## REMARKS/ARGUMENTS

**Amendments to the Drawings:**

Fig. 2

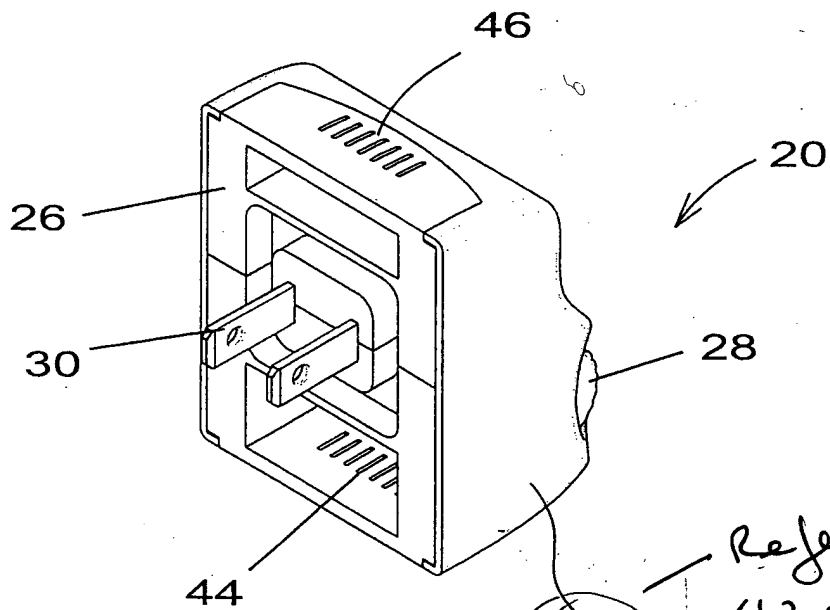
Likewise, amendments have been made at pages 9 and 12, and in Figures 2, 18, and 19, to correct an inadvertent duplication of use of the reference numerals 42 and 122. Those reference numerals have been corrected by amendments to the Figures, and to the disclosure, to substitute reference numerals 43 and 123, respectively.

Applicant inadvertently used reference numeral 42 twice, and its incorrect use in Figure 2 has been corrected. Numerals 40 and 42 clearly indicate the limits of the beam, as clearly described, for example, in the first paragraph of page 9.

In Figure 2 the reference numeral "42" has been changed to --43--.

Reference Numeral  
42 changed to  
43

Fig. 3

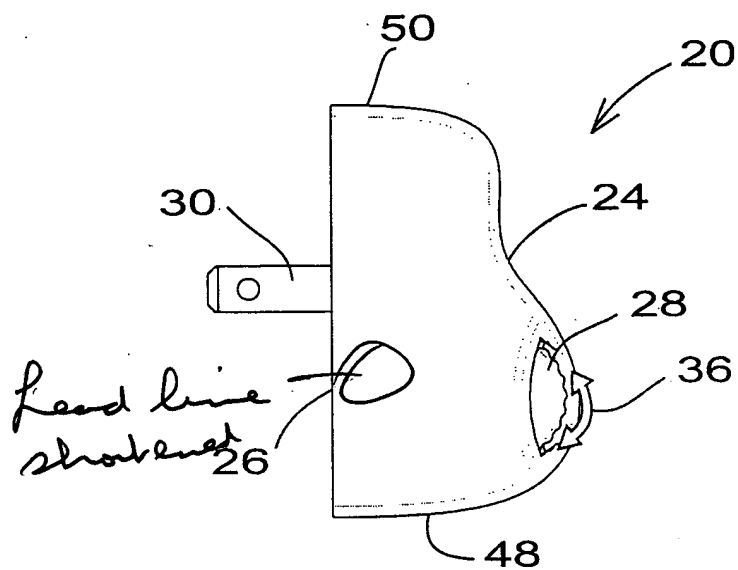
As to the alleged double use of the reference numeral 26, Figure 3 has been amended so as to ensure that the lead line associated with reference numeral 26 stops at the rear face. Use of that reference numeral is consistent throughout the Figures, as seen, for example, in Figures 4, 5, 7, 8, 9 to 12, and 15 to 17.

In Figure 3, the lead line associated with reference numeral "26" has been shortened so as to end at the rear face of the night light shown in that figure.
